Access Compliance Report

Public Rights-of-Way

(Pedestrian Signals)

Intersection ID: N/A	Main Street:	Cross Street: N/A	Location: N/A
ADA ID: D8591660777E	Signal Type: Two Push Buttons-Non APS	Overall Compliance: No	Severity Score: BTN 1:N/A BTN 2: N/A No BTN: N/A
Codes/Mitigation Info/Possible Solution		Field Measurements/Component Compliance

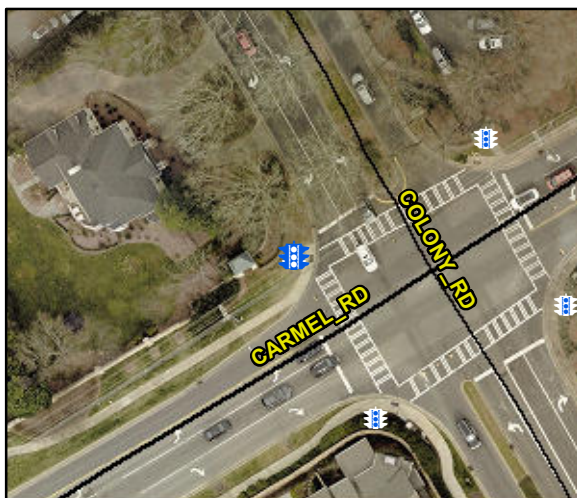
PROW/ADA: R404.2, R406.2, R404.3

Possible Solutions: Provide Push Button Extension. Remove and Replace Clear Space.
